**February 28, 2012  
Medway Planning and Economic Development Board  
Medway Senior Center  
Oakland Avenue  
Medway, MA 02053**

Re: **Lawrence Waste Site Plan**

**Re: 49 Alder Street  
Site Plan Review  
Medway, Massachusetts**

**PROPOSED SITE PLAN  
FOR  
49 ALDER STREET  
IN  
MEDWAY, MASSACHUSETTS**

1. COVER SHEET
2. EXISTING CONDITIONS
3. SITE PLAN
4. GRADING & UTILITY PLAN
5. EROSION CONTROL
6. LANDSCAPE & LIGHTING PLAN
7. DETAIL SHEET #1
8. DETAIL SHEET #2
9. BUILDING ELEVATIONS
10. FLOOR PLAN

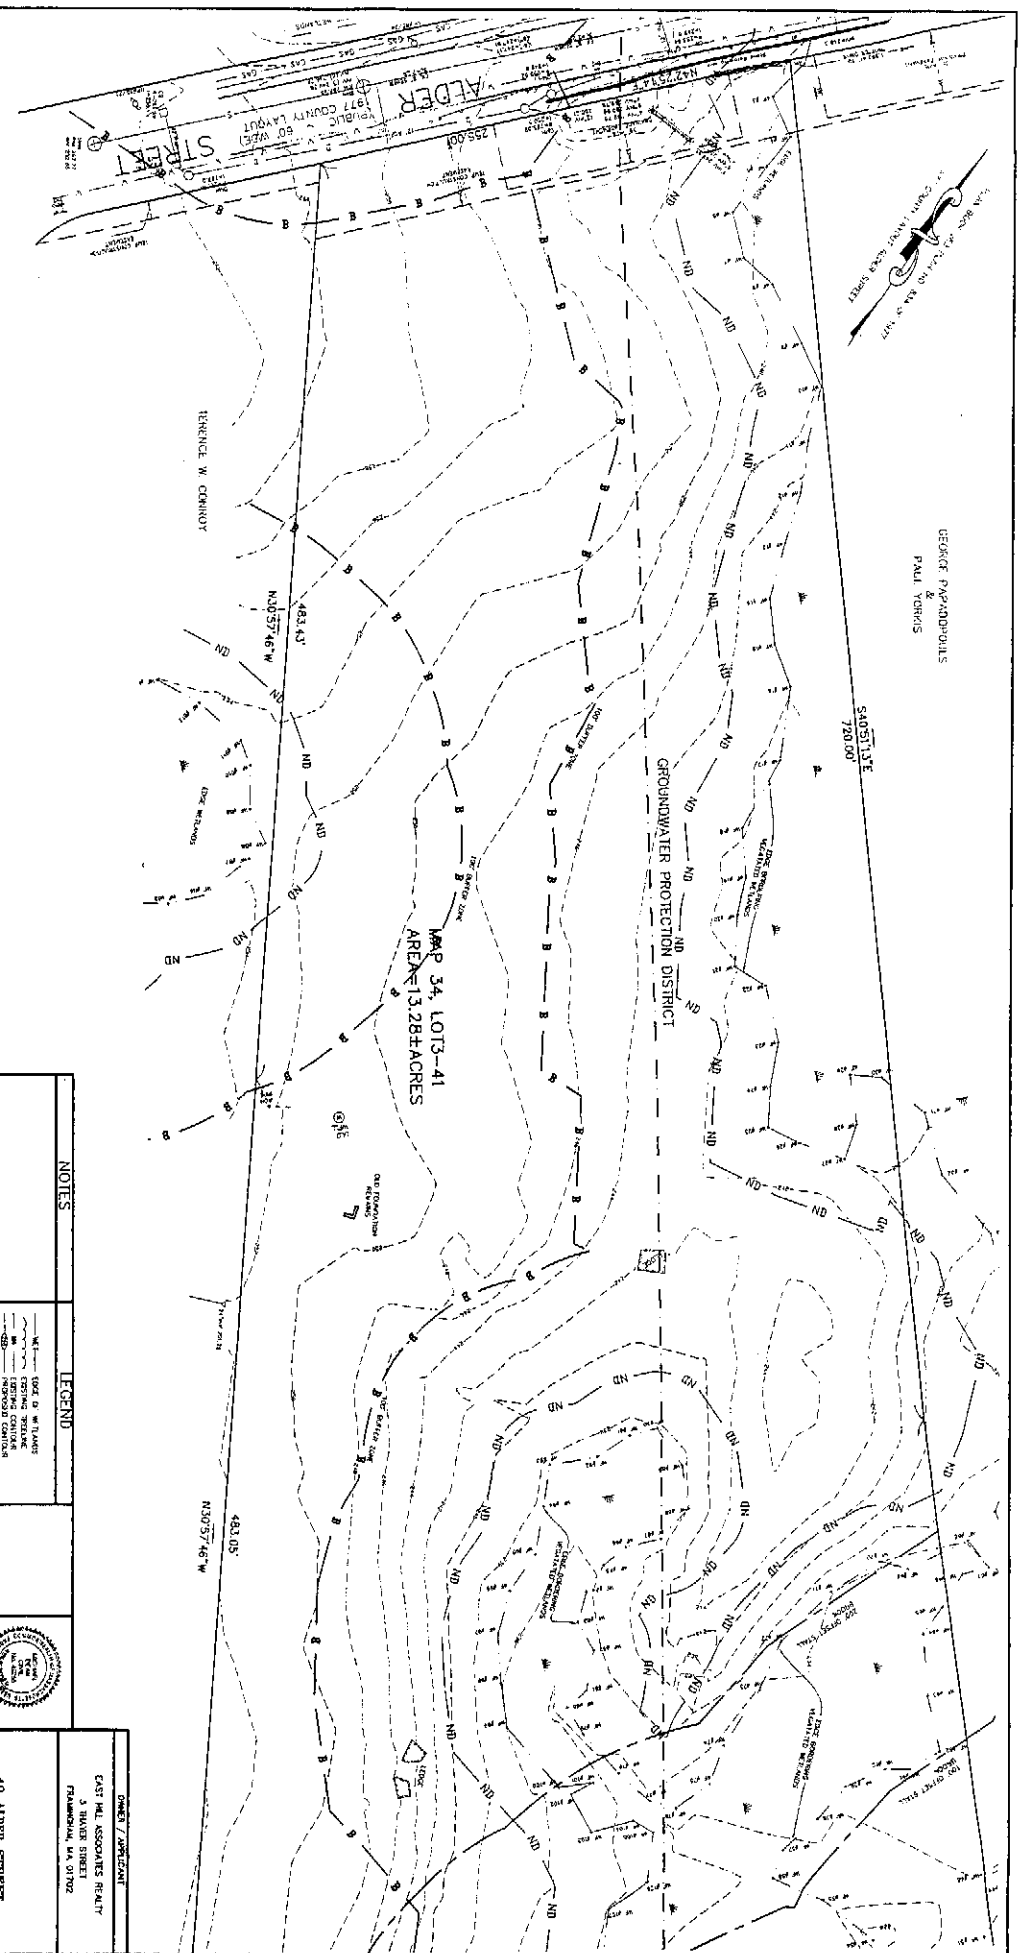
4. Elevations shall refer to North American Vertical Datum of 1988 (NAVD88). (Ch. 200 §204-4.D)
5. Cover sheet shall include Board of Selectmen's Signature Block. (Ch. 200 §204-5.A)

32. The applicant shall provide a scale for the Street and Parcel view on the Cover Sheet.
33. There is one handicap parking space shown on the Site Plan and does not match the amount proposed on the zoning table on the Cover Sheet.

**DETAIL SHEET 1\***  
PLAN OF LAND  
**MEDWAY, MA**

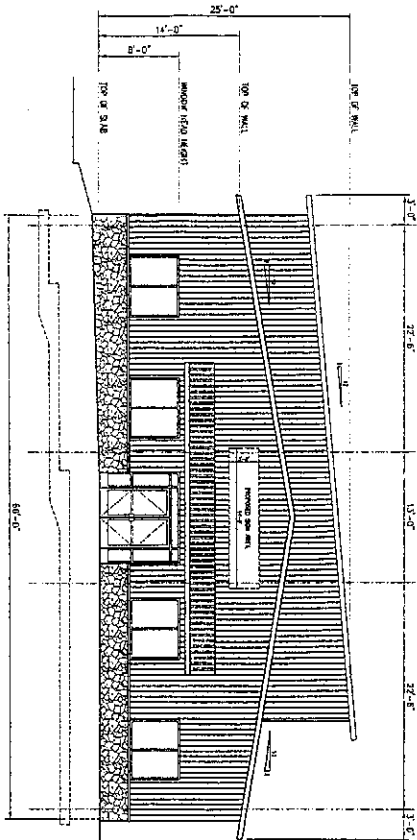
43. What is the maximum slope in the grass/landscaped area in the southwest corner of the site?
44. There is a "Typ. Concrete Walk-Curb Detail" provided on Sheet 8, however the layout plans do not show a curb around the walk adjacent to the building. Please clarify where the curb will be located.
